RE: **Gonzales Residence**
Lot 11 Blk 10 Unit 22 Volcano Cliffs
6308 Petirrojo NW
Grading and Drainage Plan
Engineers Stamp Date 12/14/15 (D10D003F11)

**RE: Drainage Resubmittal
Gonzales Residence- (D10D0003F11)
Albuquerque, New Mexico**

**RE: Gonzales Residence Lot 11 Block 10 Unit 22 Volcano Cliffs
6308 Petirrojo NW
Grading and Drainage Plan
Engineers Stamp Date 12/7/15 (D10D0003F11)**

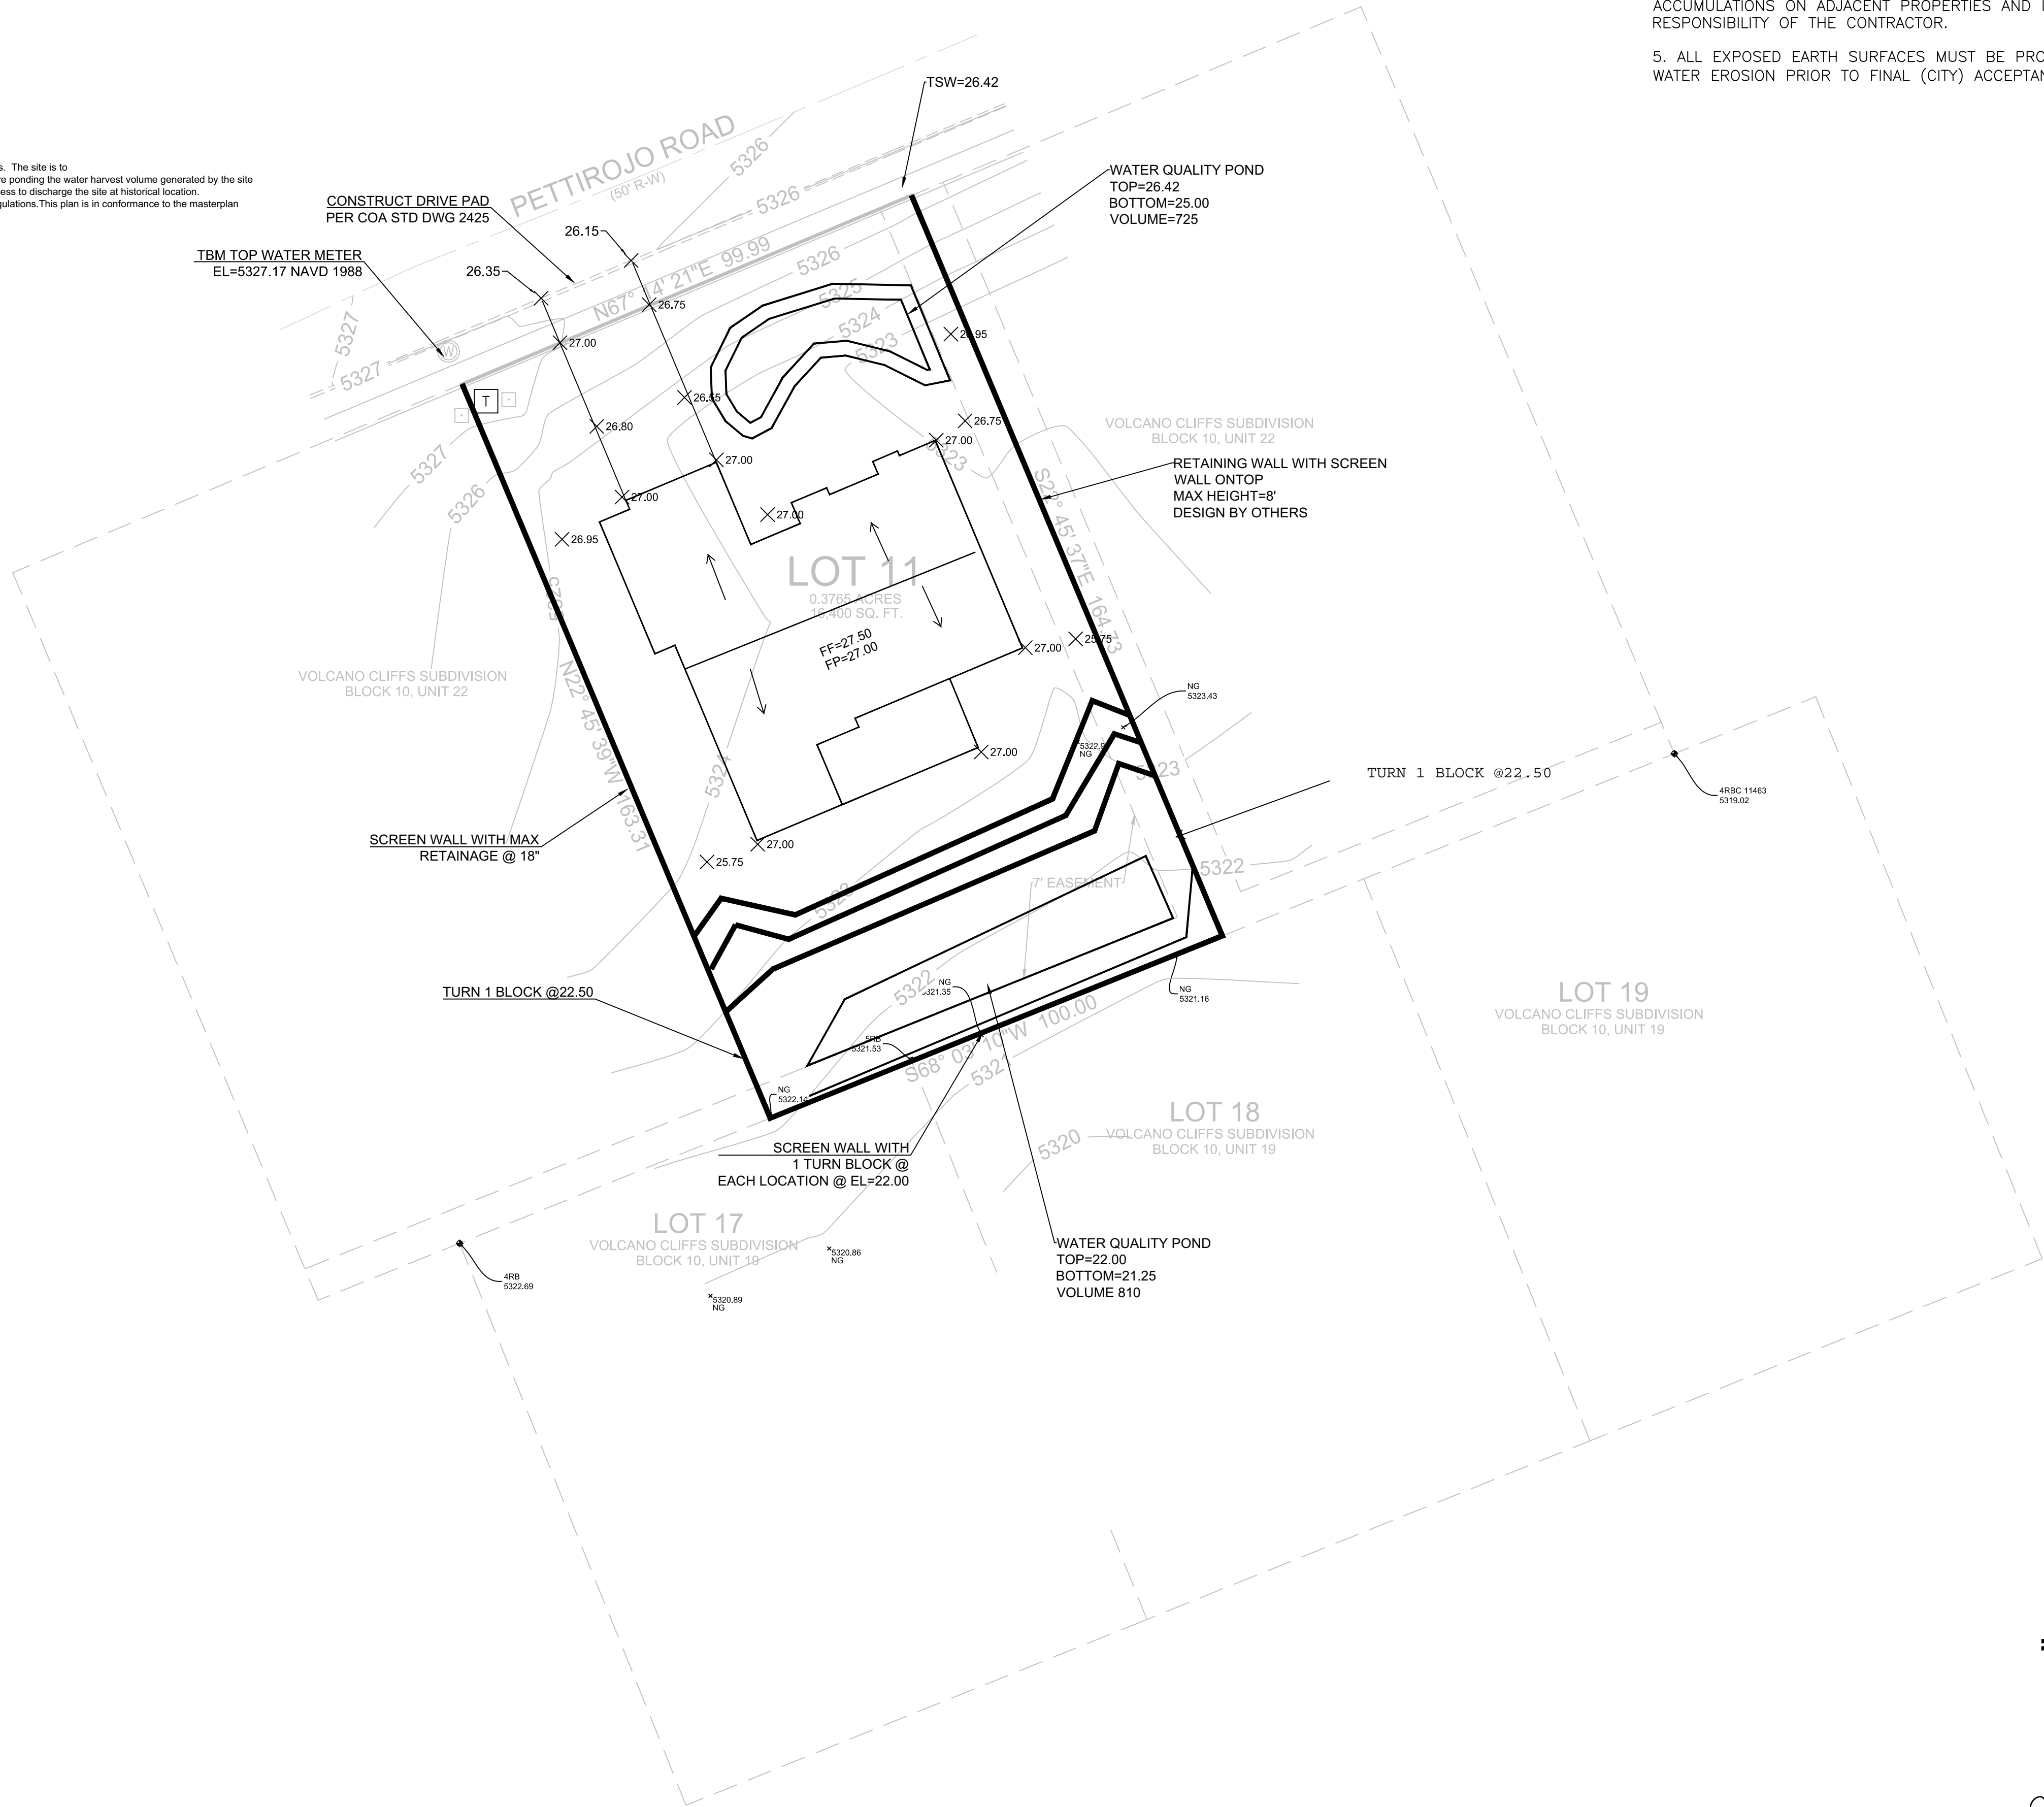
- This lot drains to two different ponds, the front half flows to pond 8 and the back half flows to pond 9, provide a site plan depicting this requirement.
- The turn blocks are located in the wrong fence line, the turn blocks should be placed in the east and west rear yard walls.

1. This lot drains into two basins, the front to pond 8 and the back to pond 9, revise site
We previously had incorrectly located the lot on the wrong block in our analysis. We have revised the plan to conform to the basin map fro SAD 228. We have enclosed this map and identified the lot on the map.
2. The turn blocks are located on wrong fence line. turned blocks should be on east and west
In order to have the site conform to the proposed condition basin map, the pad needs to be elevated. This causes retaining on the east and west property lines. We have added turned block on these walls at the south portion of the lot, where the flow can be accepted and passed. Based upon the existing contours and the location of Pond 9, we propose to have the turn blocks on the south wall remain. This design better matches existing and proposed flow conditions shown in the SAD 228 drainage plan.
